Project Name: **Glasgow High School
Culinary Kitchen Renovation**

Project Number: BSA+A # 12.003

Subject: **ADDENDUM 4**

Reference: E-100 Drawing: SKE1

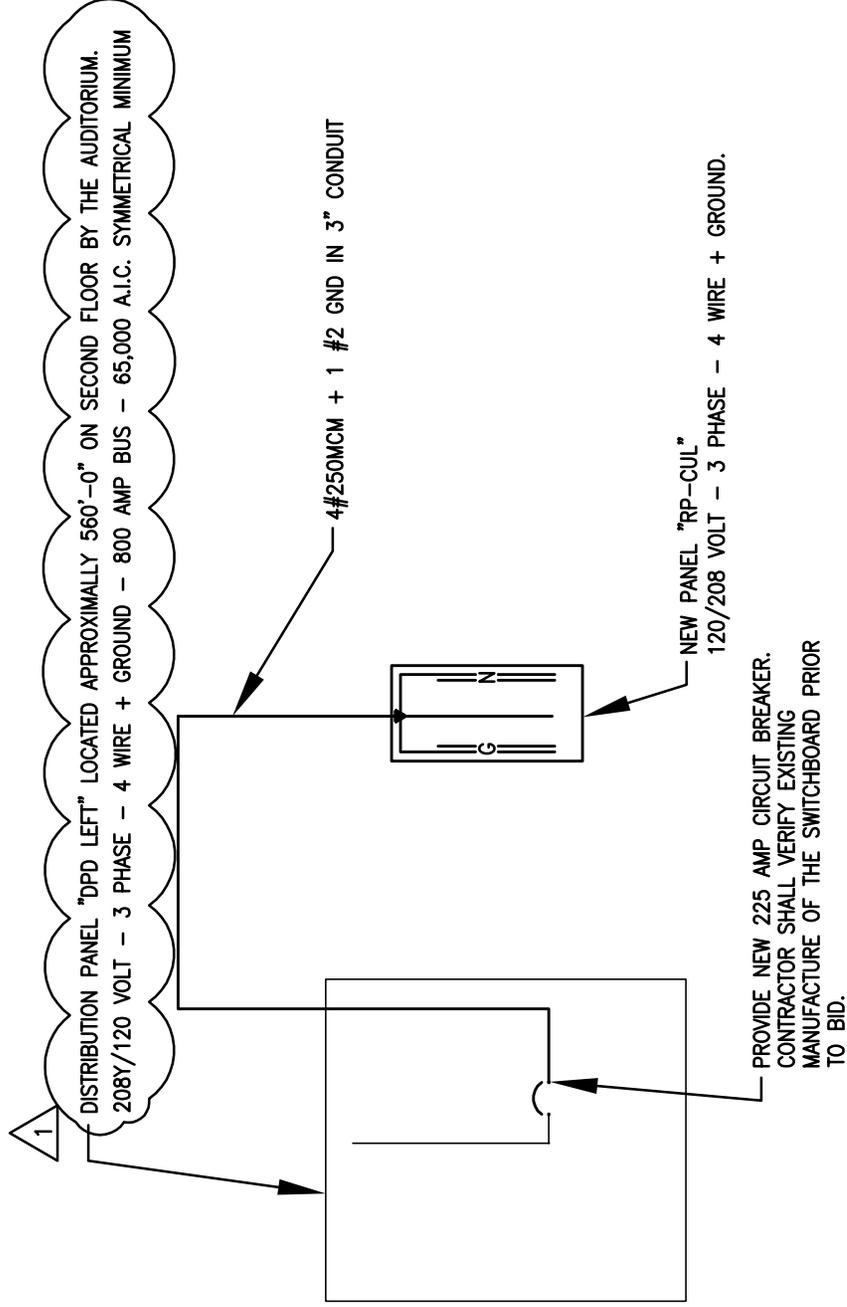
Item No.	Description:
D-1	<p>Drawing E100 Revise Distribution Panel name for new providing service to new panel "RP-CUL". Refer to attached Sketch SKE1.</p>
